APPLICATION NO.	FILING DATE	FIRST NAMED INVENTOR	ATTORNEY DOCKET NO.	CONFIRMATION NO.
10/766,162	01/28/2004	Andi Vonlanthen	31856US3	3393
116	7590	06/19/2006	EXAMINER	
PEARNE & GORDON LLP 1801 EAST 9TH STREET SUITE 1200 CLEVELAND, OH 44114-3108				LE, HUYEN D
		ART UNIT		PAPER NUMBER
		2615

Office Action Summary	Application No.	Applicant(s)	
	10/766,162	VONLANTHEN, ANDI	
	Examiner	Art Unit	
	HUYEN D. LE	2615

DETAILED ACTION

FIG. 9

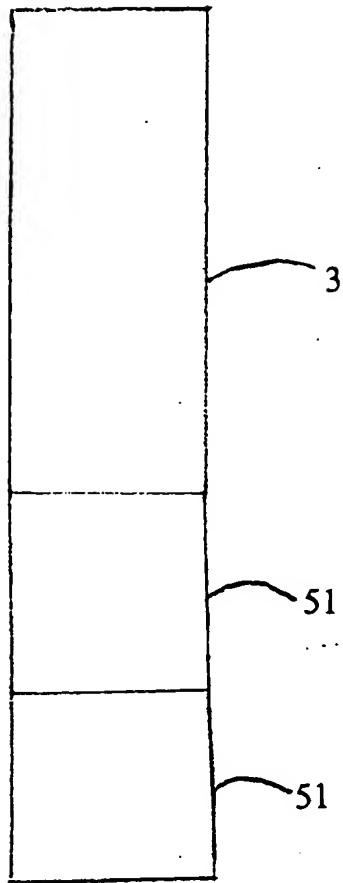
1. The amendment filed May 19, 2006 is objected to under 35 U.S.C. 132(a) because it introduces new matter into the disclosure. 35 U.S.C. 132(a) states that no amendment shall introduce new matter into the disclosure of the invention. The added material which is not supported by the original disclosure is as follows:

The text added to the following page 6, line 24: "Figure 9 schematically illustrates the basic housing of the device in the invention and two extra modules that can be stacked onto the basic housing", and page 11, line 24: "more such modules 52 can be stacked on the basic housing 3 of the hearing aid" are not supported by the original specification.

The newly added drawing Figure 9 and the amendments to the Specification on page 11, line 24 have not been entered since the specification, as originally filed, does not provide support for the invention is now claimed.

The original specification does not disclose that the modules 51 can be stacked on the basic housing 3 of the hearing aid, and how one of the extra modules 51 being a wireless signal transmission module are releasably mounted to another one of the extra modules 51. In the original specification, page 12, lines 2-8, the Applicant discloses that the modules 51 (an interface unit for wireless signal transmission of a programming plug-in unit, another audio

input, a larger storage battery compartment, or a mechanical activating unit, ect, see page 11, lines 12-16) can be stacked on the basic module of the hearing aid.

Do not enter
✓
6/9/06

Applicant is required to cancel the new matter in the reply to this Office Action.
